Addendum No. 2

Subject: W.B. Saul High School – New Livestock Center
SDP Contract Nos. B-011C, B-012C, B-013C of 2017/18

This Addendum, dated 25th of April, 2018, shall modify and become part of the Contract Documents for the work of this project. Any items not mentioned herein, or affected by, shall be performed strictly in accordance with the original documents.

DRAWING NO.
C1.03
SHEET 4 OF 29

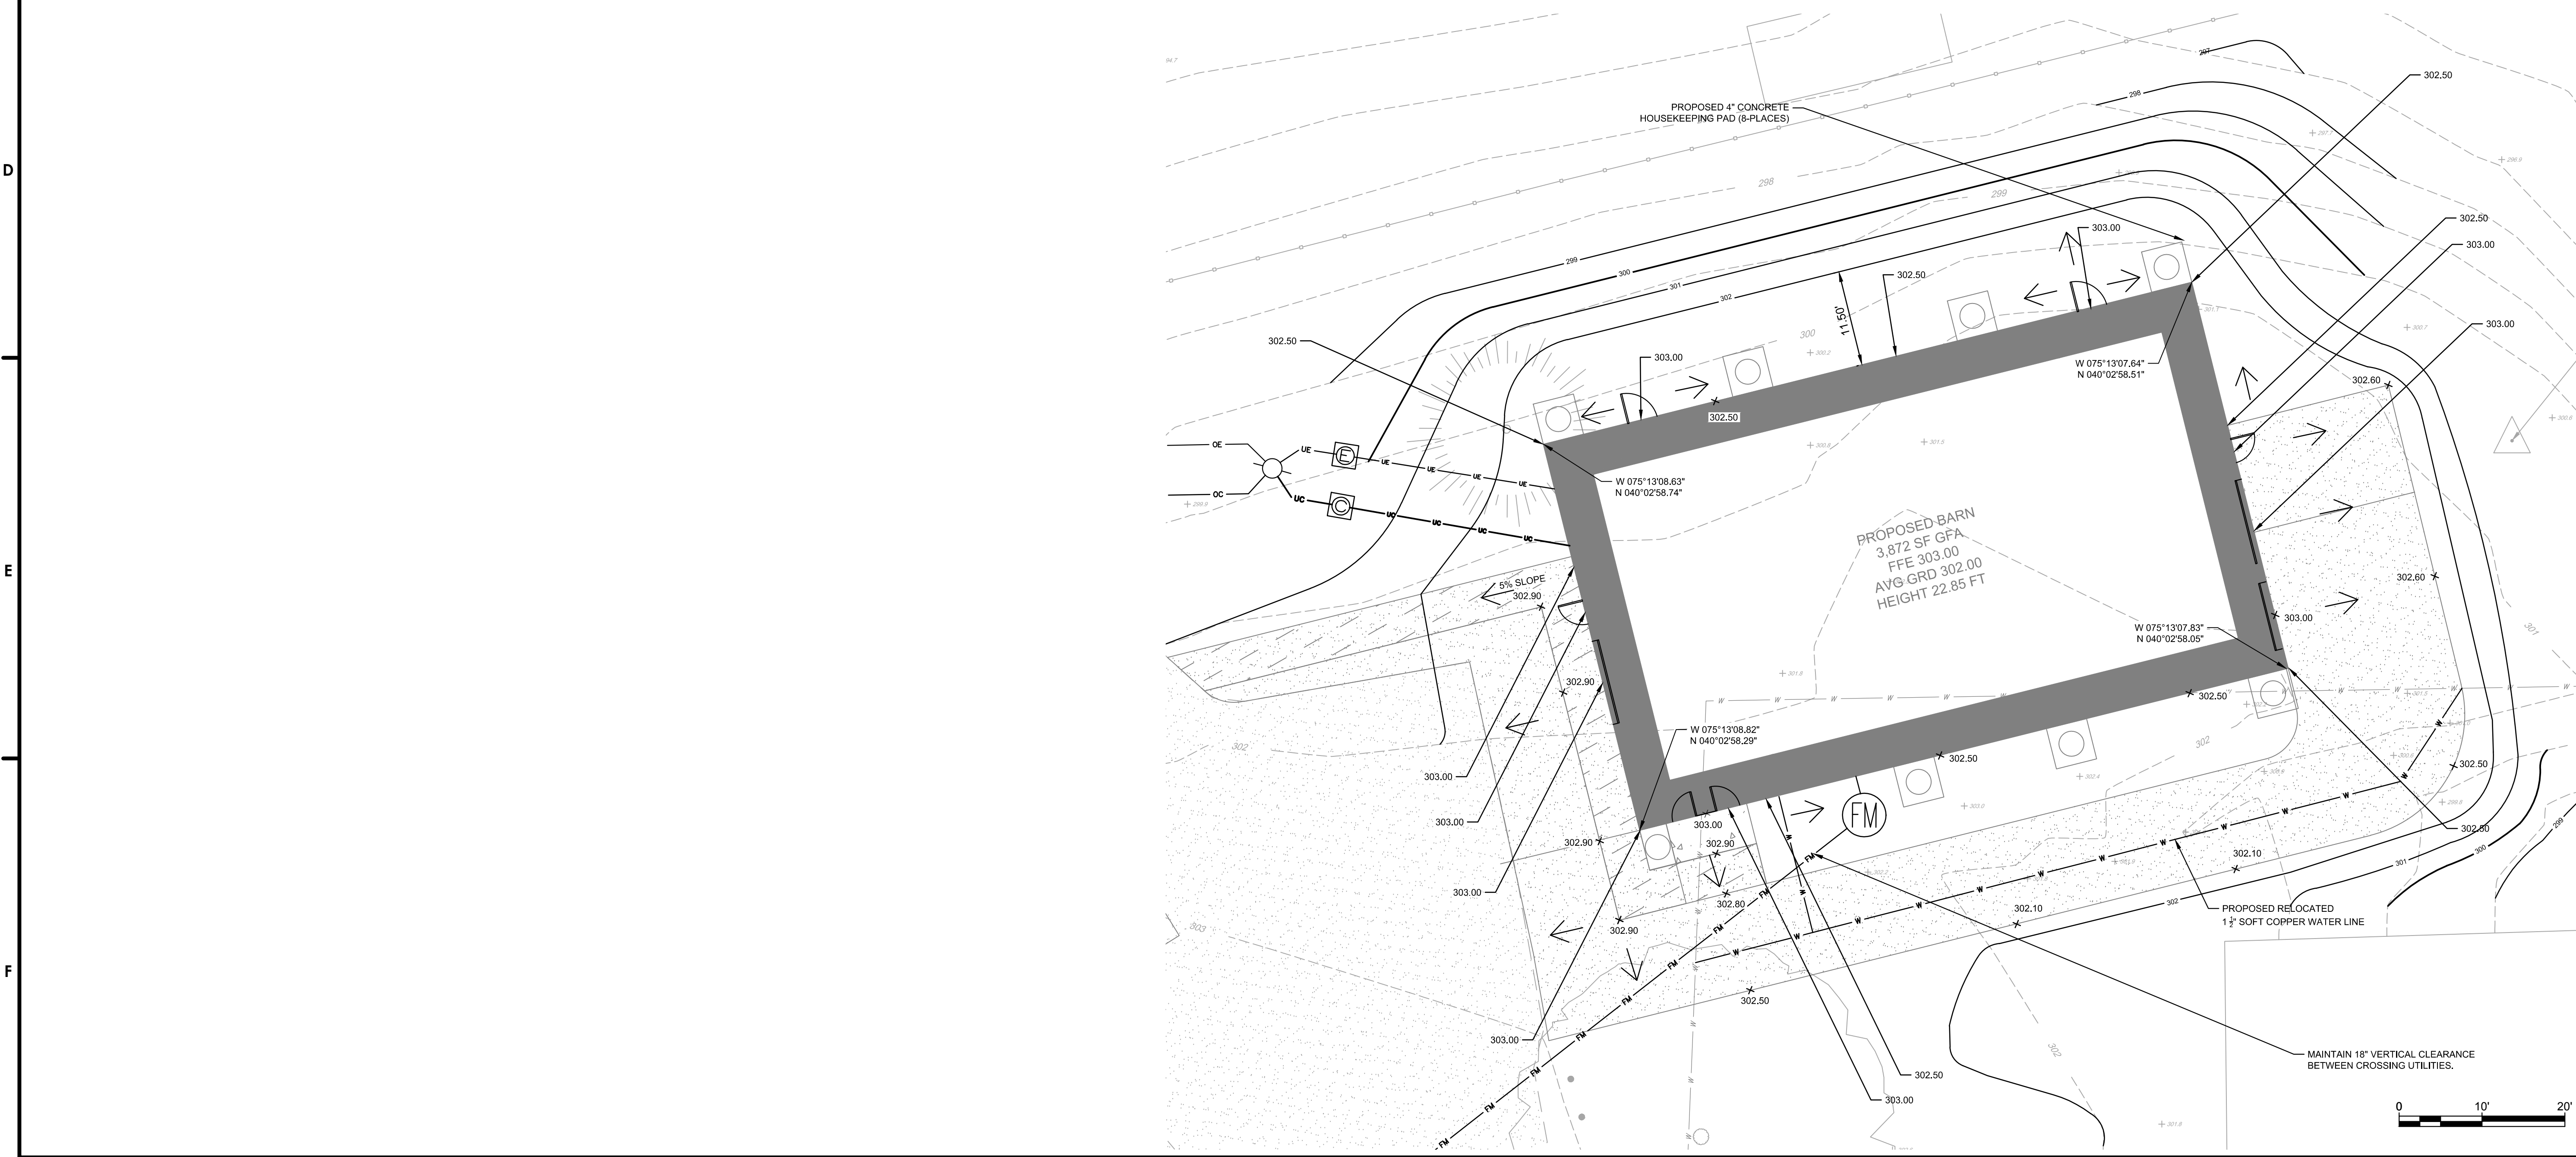
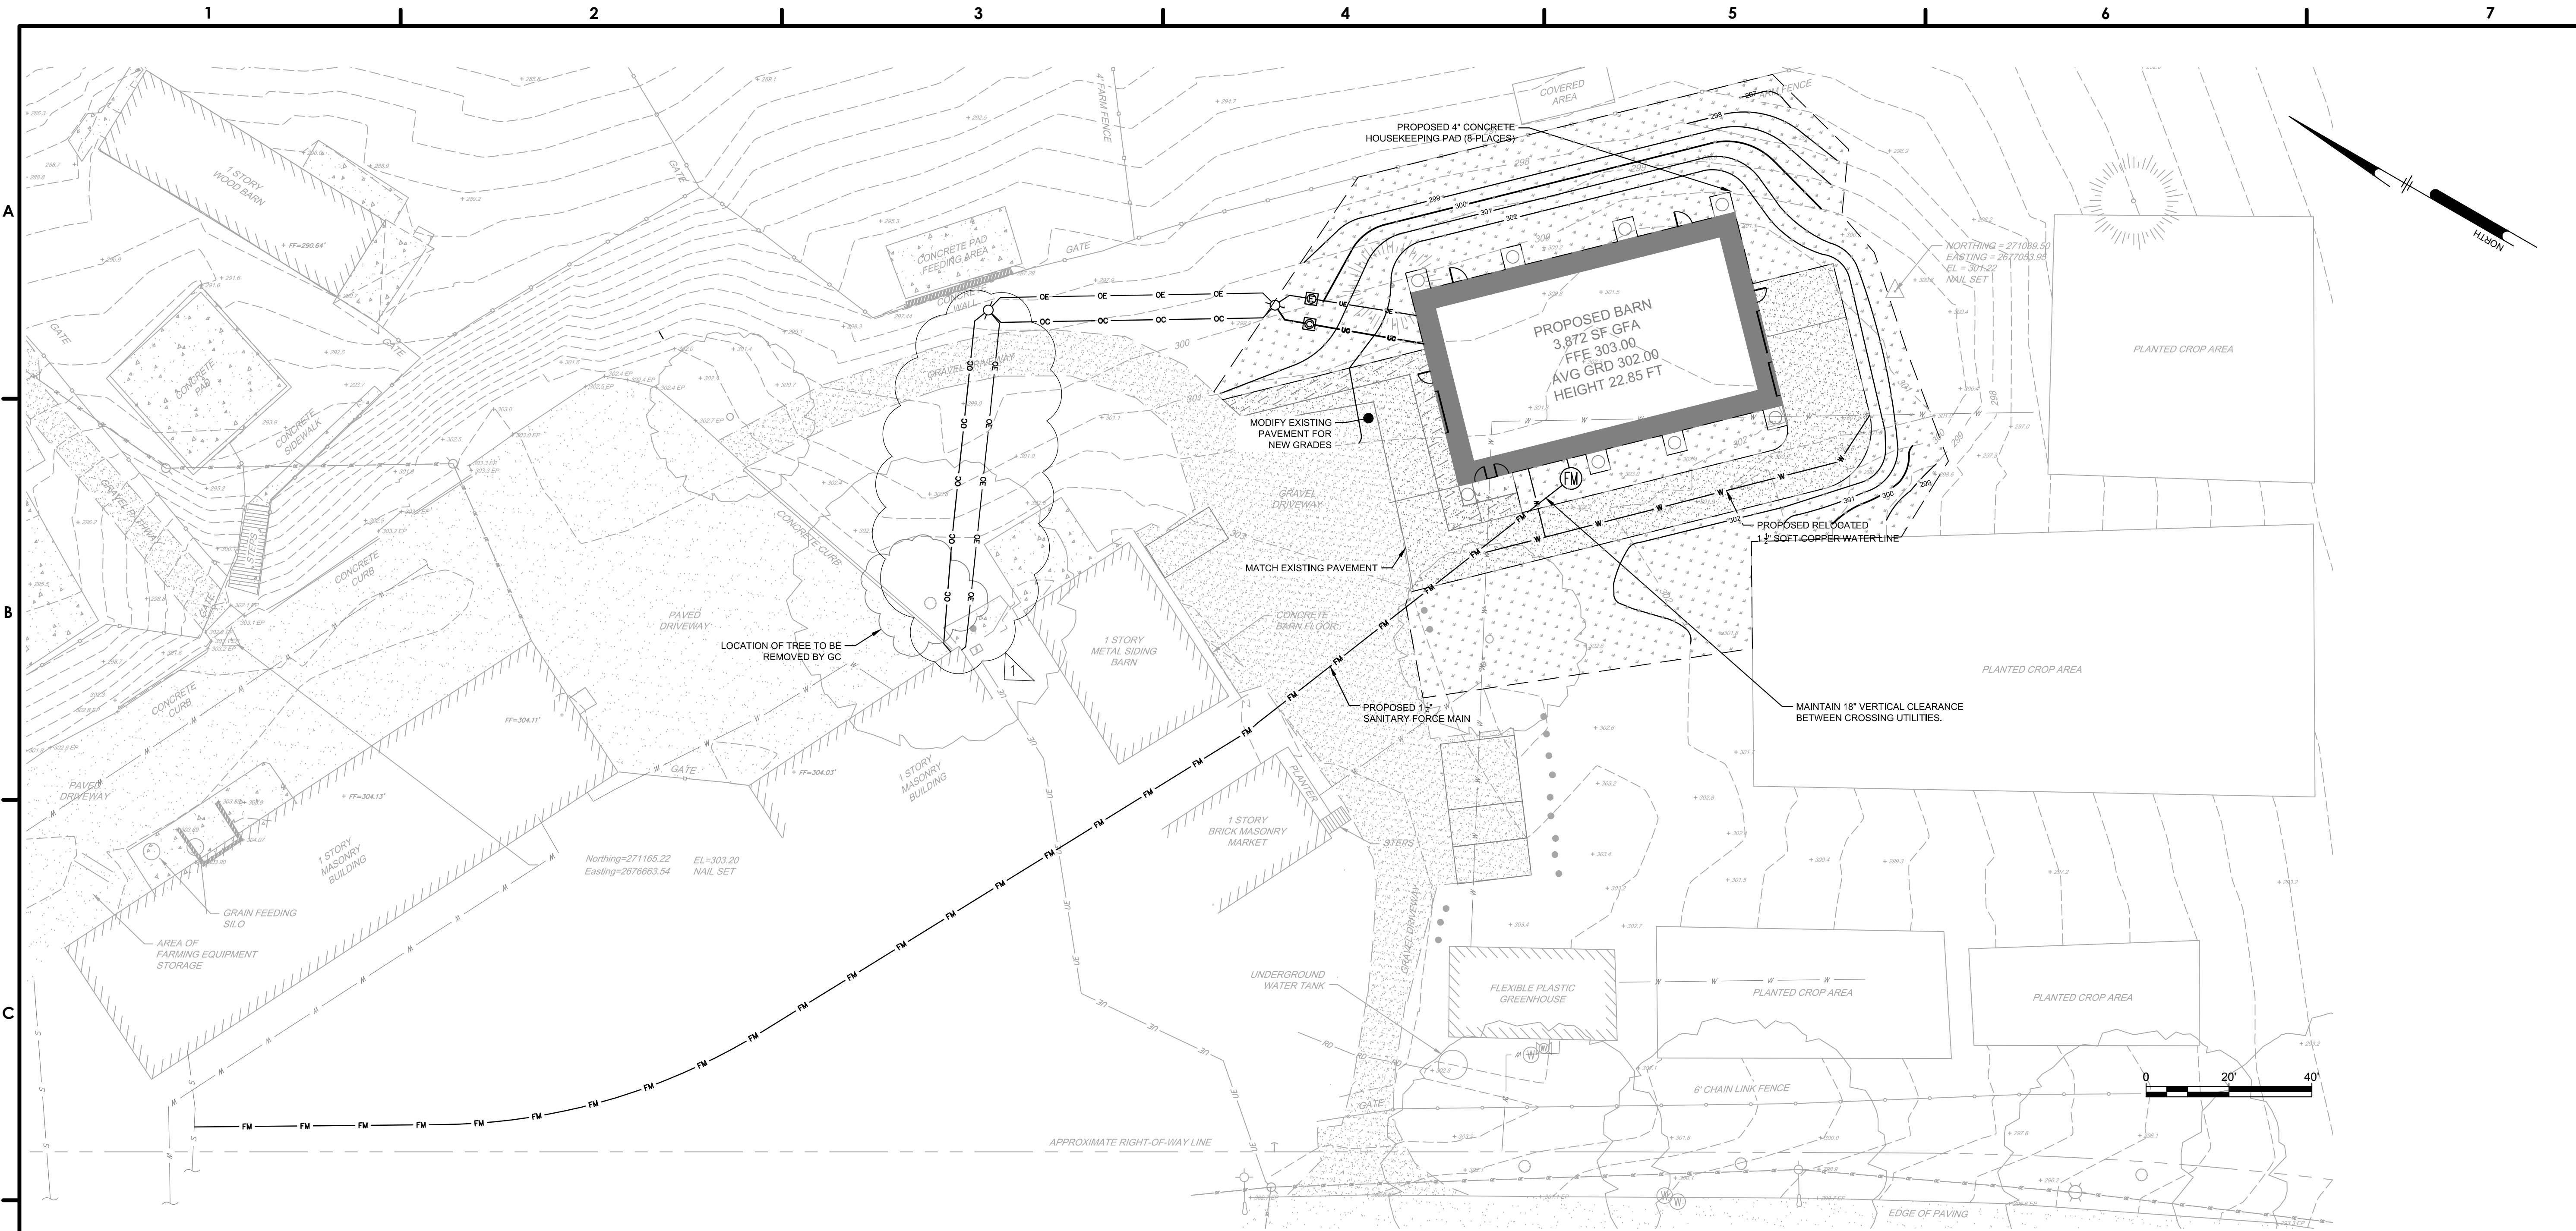
- a. Revised the routing of the overhead electric communications utility.
- b. Added note for the tree at the northeast corner of the existing Ag Sciences Building to be removed by the General Contractor.
